Product Change Notification

Date Issued :	November 14, 2023	PCN Number :	514514
Reason for Change :	Change to Product		
Description of Change :	Molex is changing the internal plug from a plastic over molded ceramic ferrule to a metal press fitted ceramic plug for the ST connector part numbers in attached impacted parts list to standardize our connectors and ensure source of supply.		
Assessment of Change :	Reliability Test Report/s		
Planned Implementation Date :	May 14, 2024		
Sample Availability Date:	February 15, 2024		
Internal Molex Qualification Date :	January 01, 2024		
Last date to request Samples by Customer :	January 31, 2024		
Traceability Code Markings / Date :	No special marking on the product or packaging

Before Picture

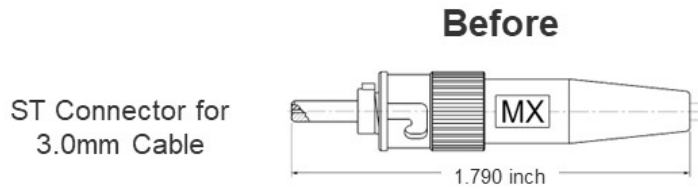
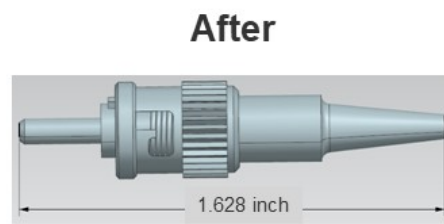
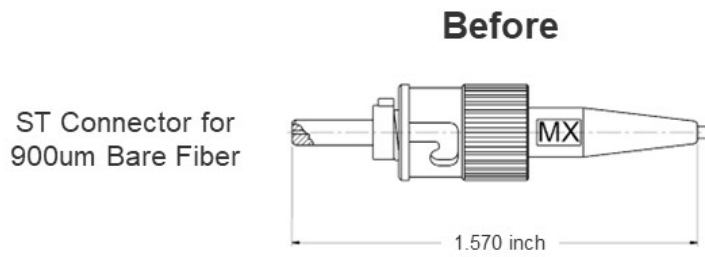
- Molex is changing the internal plug from a plastic over molded ceramic ferrule to a metal press fitted ceramic plug for the ST connector part numbers in attached impacted parts list to standardize our connectors and ensure source of supply.
- Product Impact
 - No impact to connector mating, function, or performance.
 - The internal plug is changing from plastic to metal.
 - The length and appearance of the boot will change.
- Part Number Impact
 - See attached impacted parts list
- Qualification Reports and samples available upon request after the date shown above
